N472NAS1

TECHNICAL BULLETIN

Service Action: Windshield Molding Tapping Noise

| MODEL: | MODEL YEAR: | VIN: |
|---------------|-------------|---------------|
| Defender (LE) | 2020 | 000584-008252 |

4.

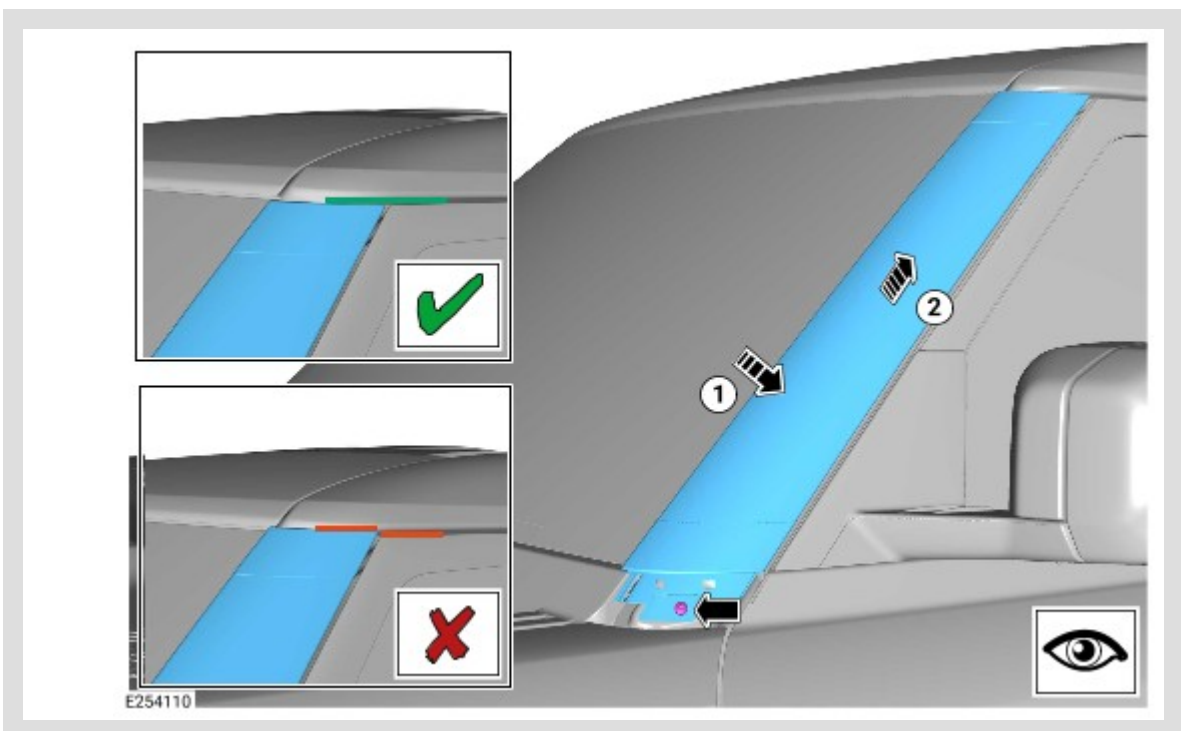
Locate the 11 windshield molding retaining ribs as shown highlighted.

- Clean the area around each windshield molding retaining rib.
- Apply felt tape to cover each of the 11 windshield molding retaining ribs as shown.
